Product / Process Change Notification (PCN)

PCN #: PCN_WL-SUMW_20180930

Affected Series: WL-SUMW;153353xxx

Pictures of the product before and after

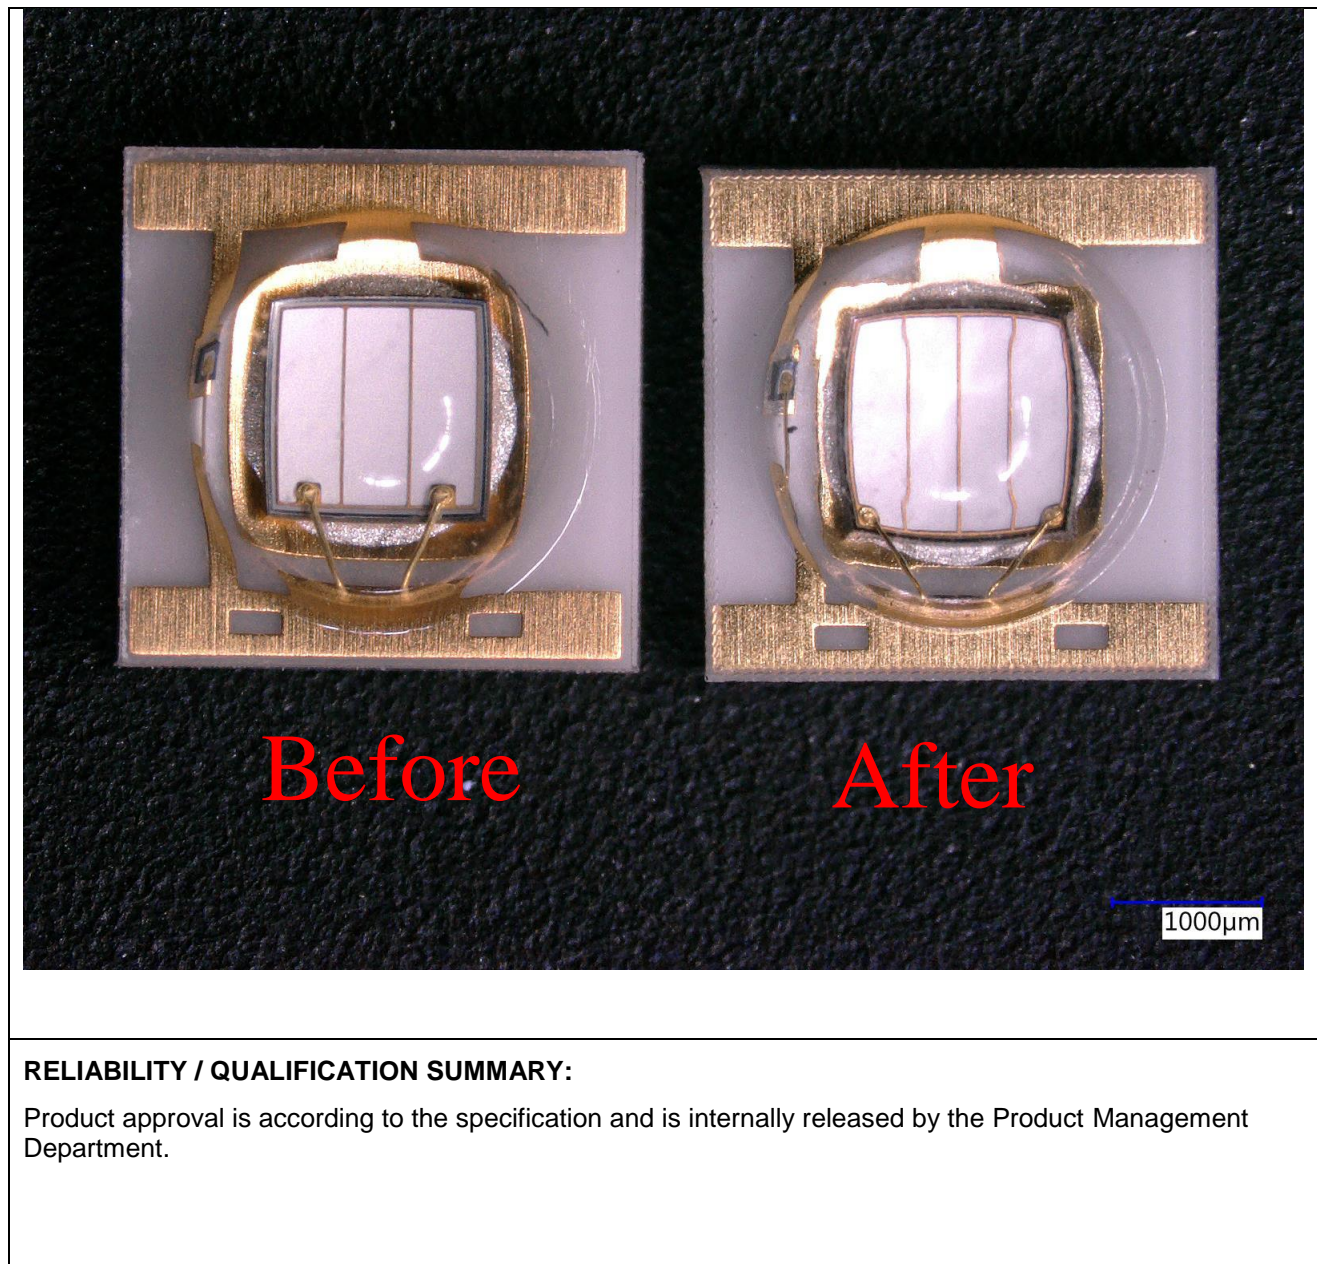
In order to meet current market demands, Würth Elektronik will change the chip to be able to deliver higher optical power.

With the change the minimum output power for the WL-SUMW increase to 800mW and the typical optical power to 1000mW
